July 2016
FL702A-H
NHTSA #16V-121
REVISED NOTICE

Subject: FCCC XCP Chassis Power Steering Hoses

Models Affected: Specific Freightliner Custom Chassis XCP chassis manufactured April 26, 2013, through January 17, 2015.

Fig. 1, Steering Pump, Cummins ISX12

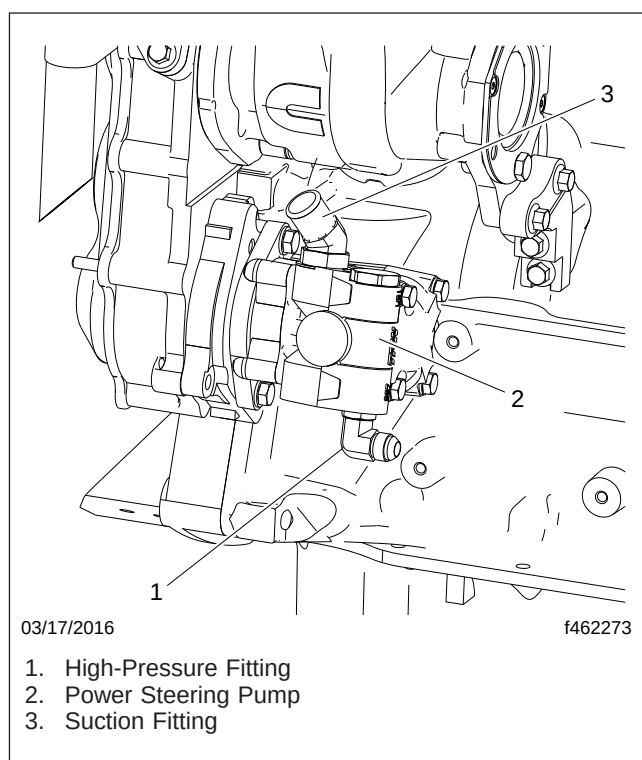
24. Using the mounting bolts, install the power steering pump. Tighten the mounting bolts 25 lbf-ft (34 N·m). See [Fig. 1](#) and [Fig. 2](#).
